ADDENDUM NUMBER: Three (3)

DATE: December 1, 2025

PROJECT: MONTGOMERY COUNTY EMS STATION 28

DESIGNER: DOUGLAS A. JONES, ARCHITECT

SHEET E4.2 ELECTRICAL DETAILS & RISER & Addendum No. 02 - ITEM 15; Delete Sheet E4.2 dated 11/03/2025 in its entirety. Substitute therefor: Sheet E4.2 - ELECTRICAL DETAILS & RISER dated 12/01/2025 attached hereto.

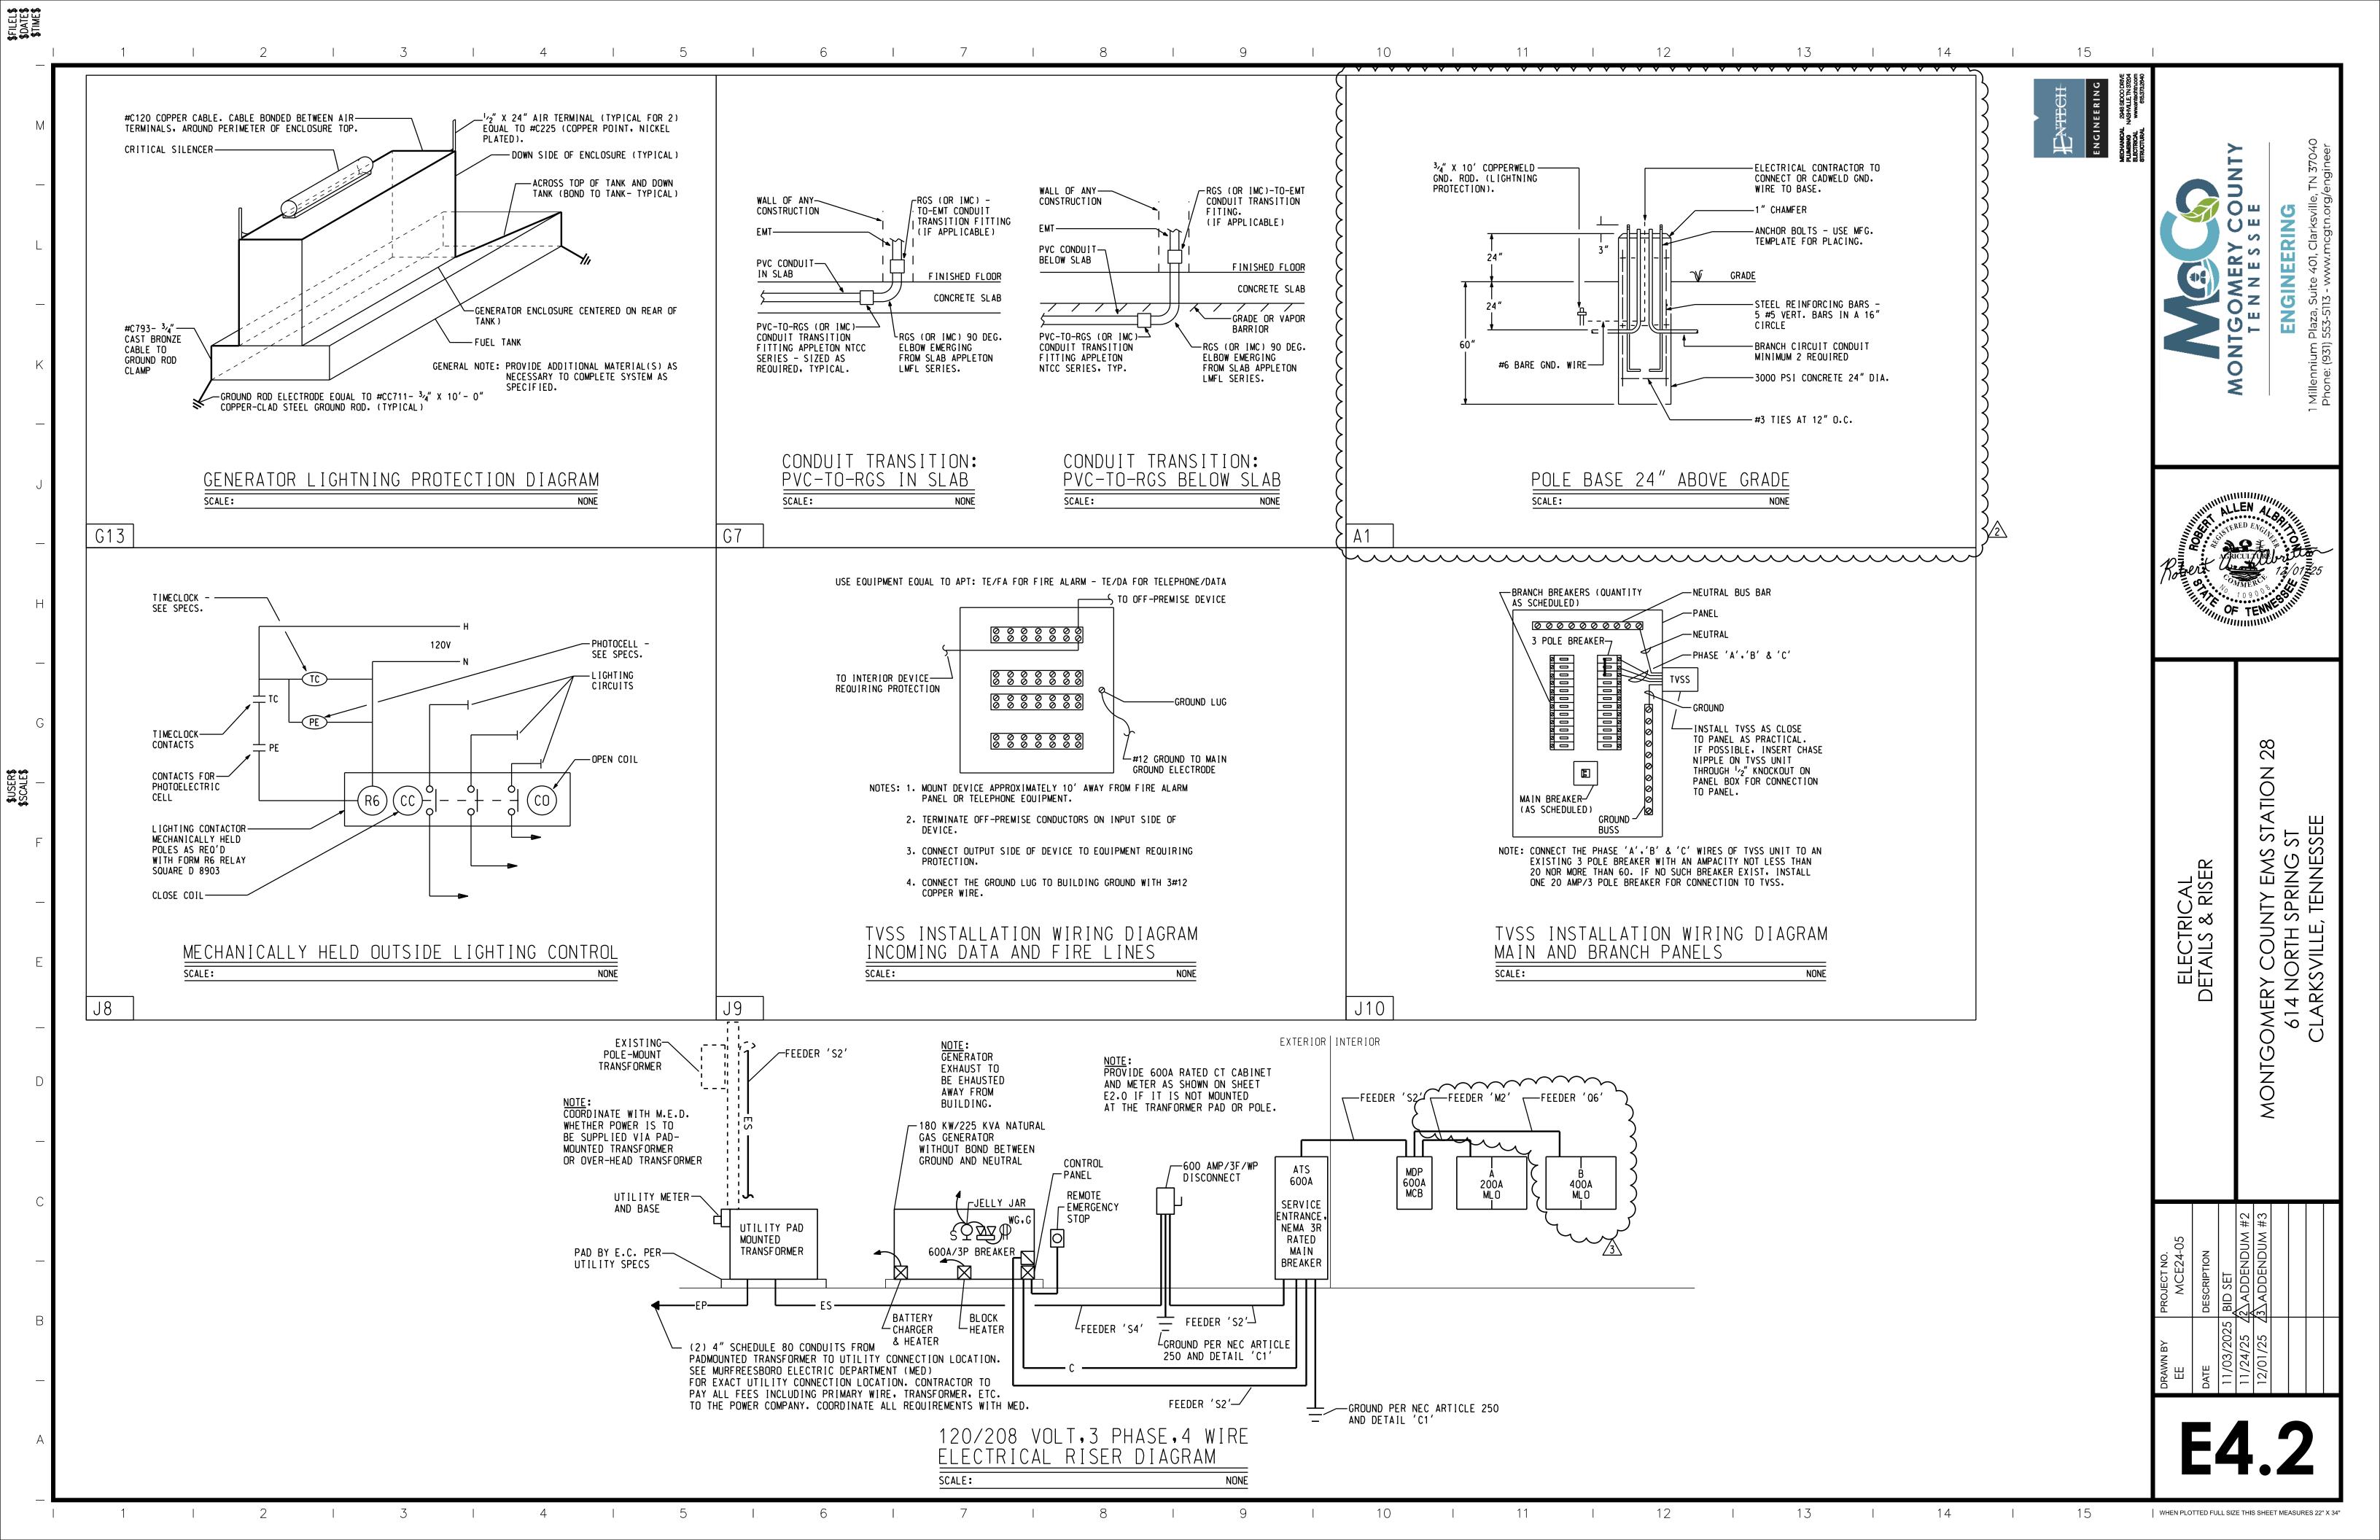
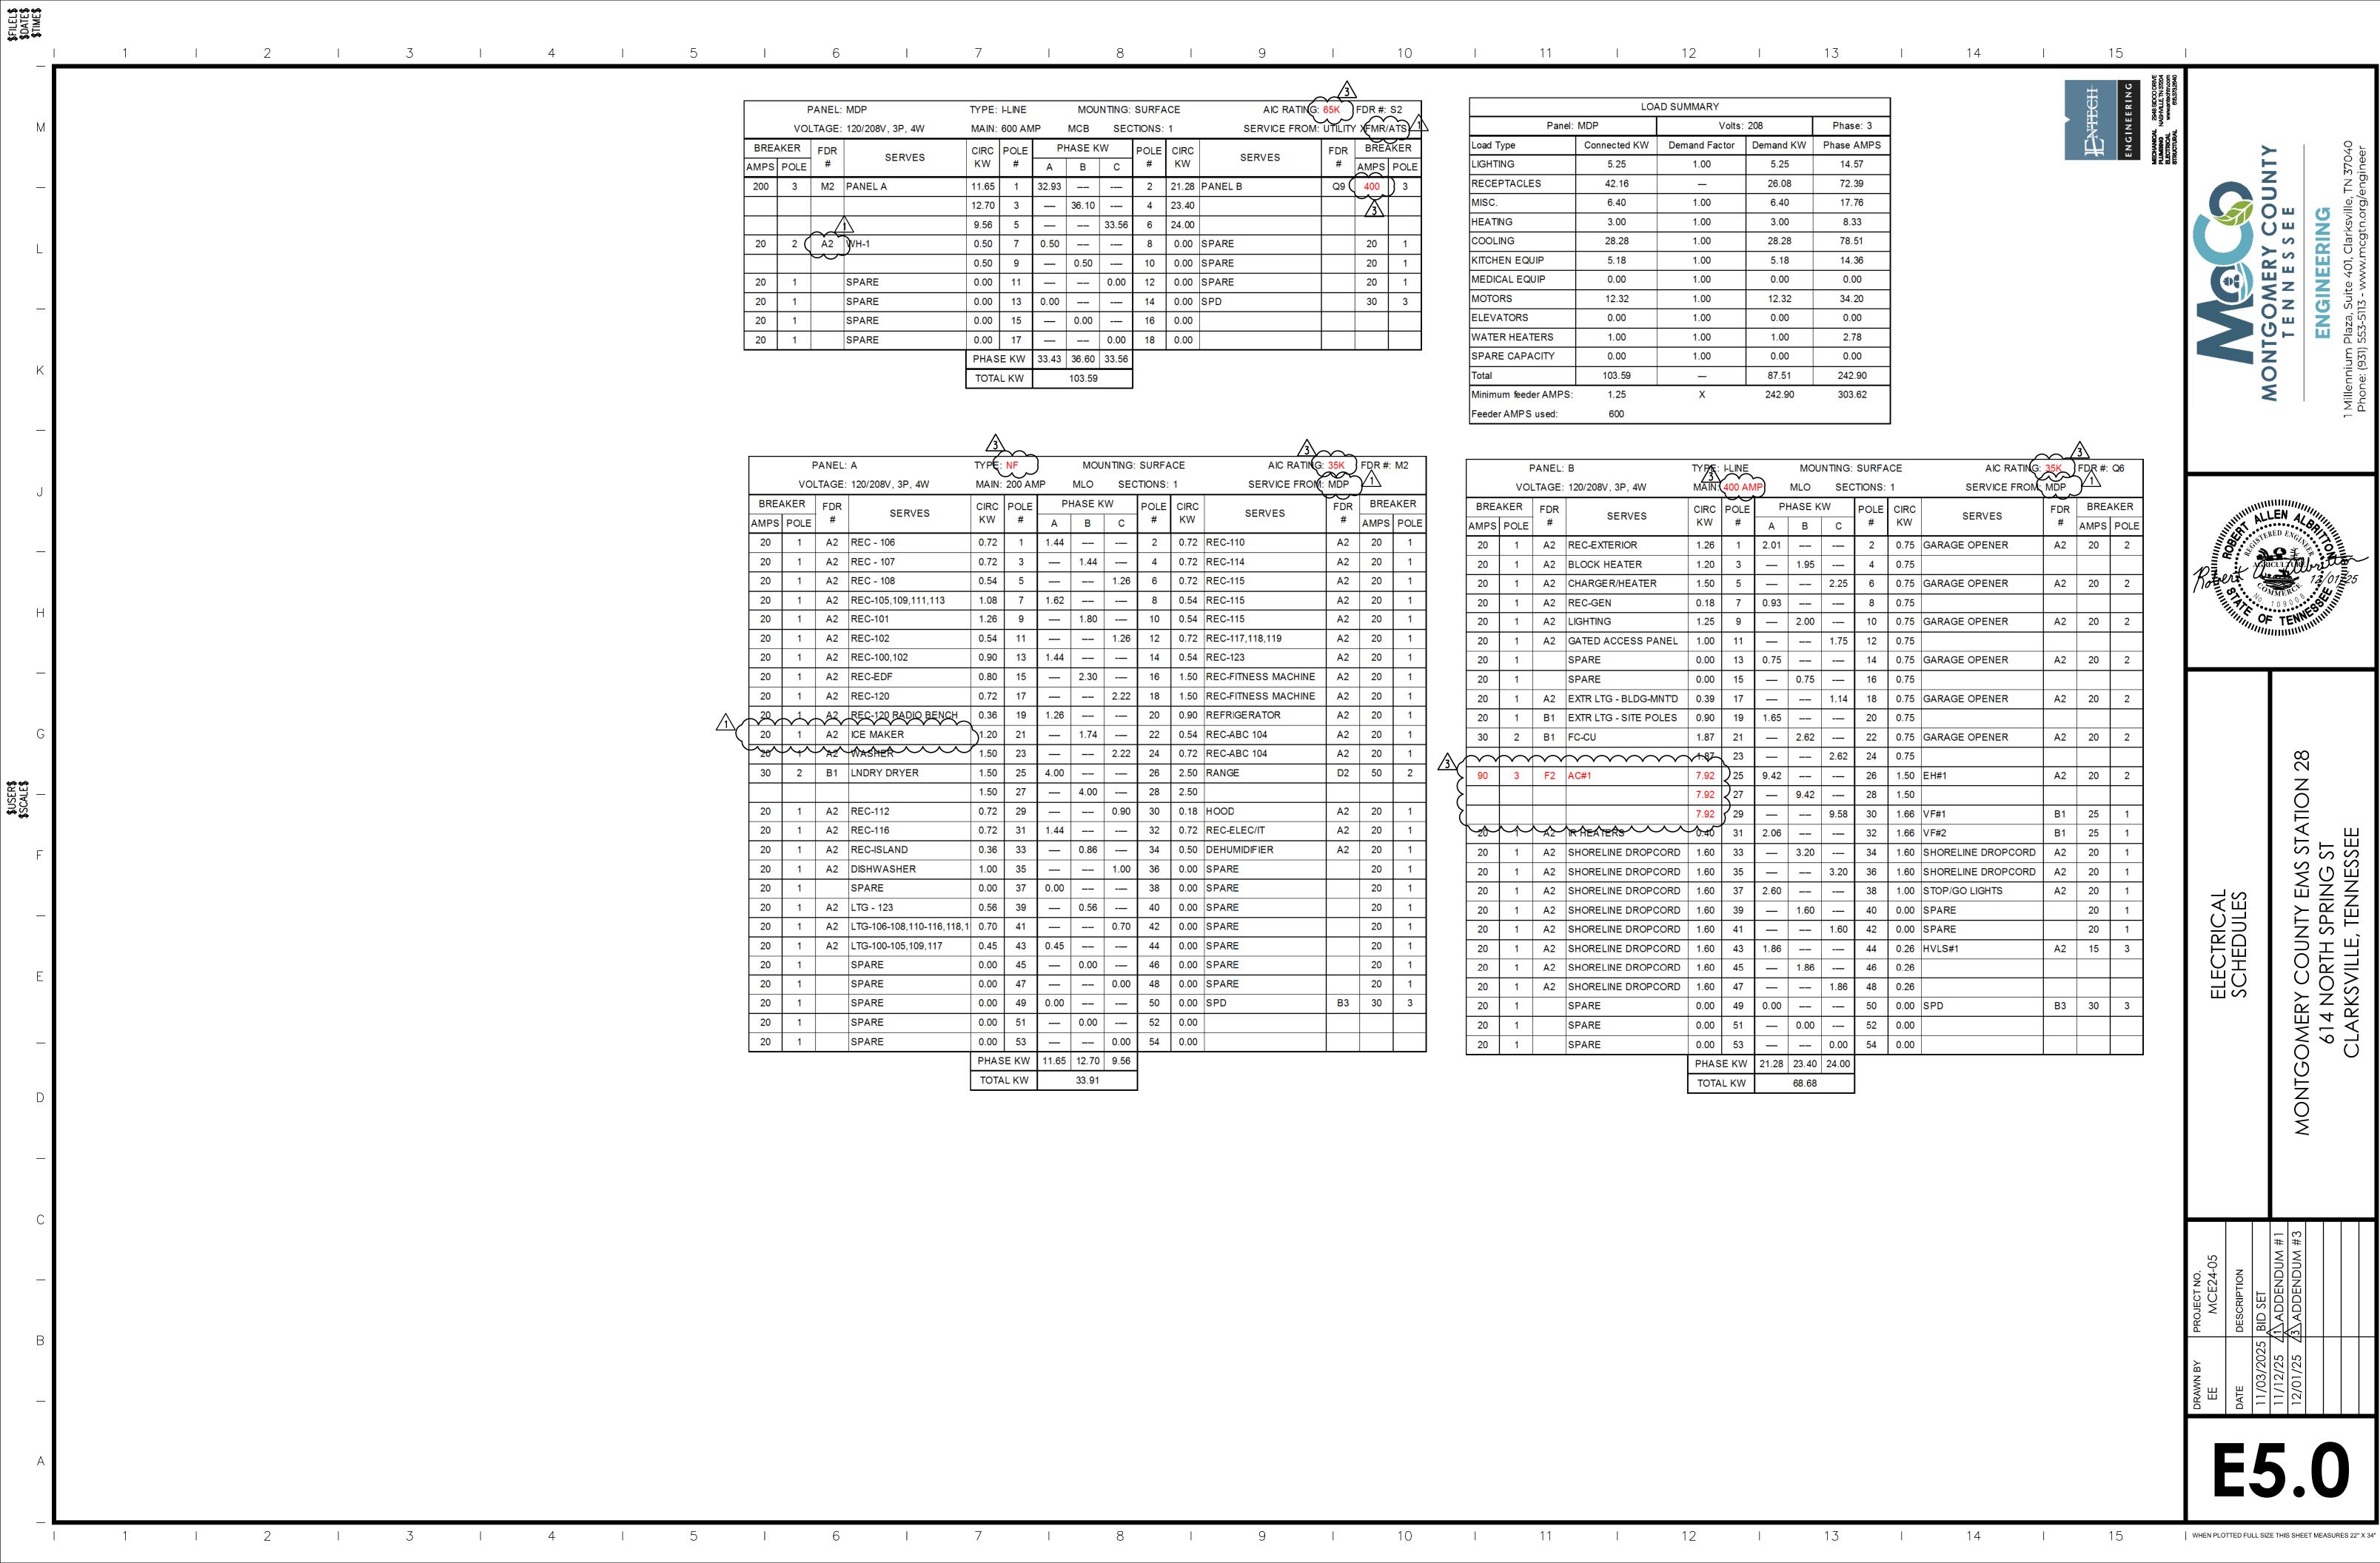
Clarification: Added feeder sizes to the riser diagram & Panel 'B' size updated in riser.

SHEET E6.0 – ELECTRICAL LEGENDS; Delete Sheet E5.0 dated 11/12/2025 in its entirety. Substitute therefor: Sheet E6.0 - ELECTRICAL LEGENDS dated 12/01/2025 attached hereto.

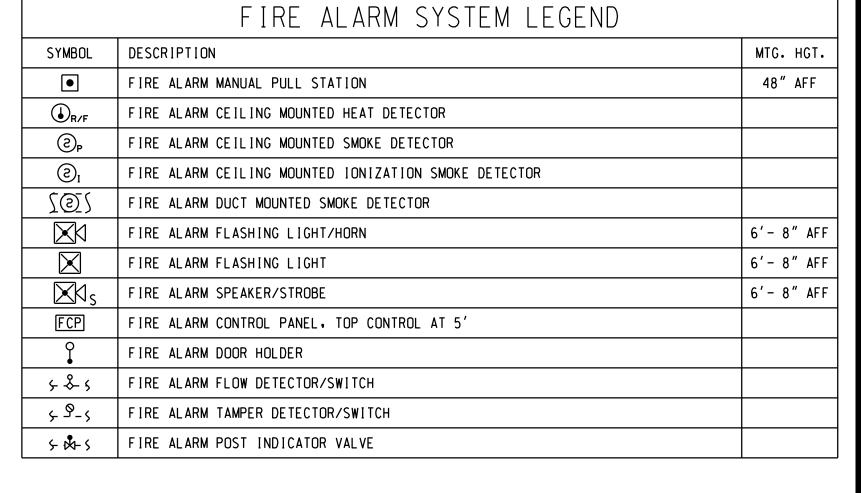
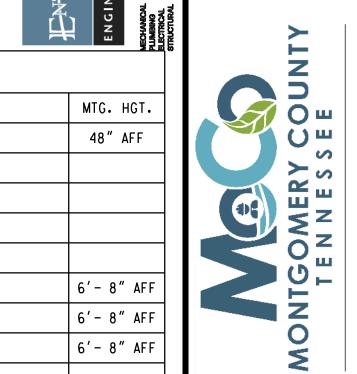
Clarification: Added feeders M2 and Q6 to the Feeder schedule/legend.
